CITY OF ALBUQUERQUE

RE: ST. Martins Hospitality Center
Grading and Drainage Plan
Engineer's Stamp Date 2-3-2017 (File: J18D182)

Based upon the information provided in your submittal received 2-8-2017, the above referenced Grading and Drainage Plan cannot be approved for paving permit until the following comments are addressed:

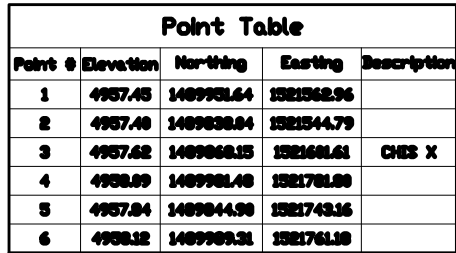
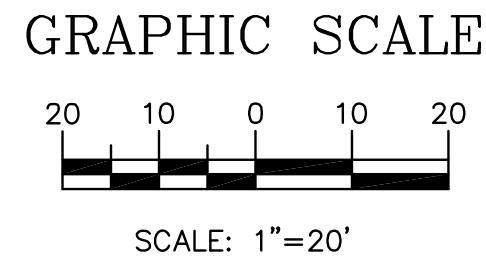
1. Provide onsite and offsite flow narrative.
2. Hinge line between the east and west side of the site will be beneficial to get half of the onsite runoff drain to the pond or make sure stormwater quality pond placed where flow can get to it.
3. Peak discharge for proposed condition should be the same or less than the existing conditions.
4. Does the northerly building roof drain directly to Mountain Road?
5. Is there a trash enclosure on site?
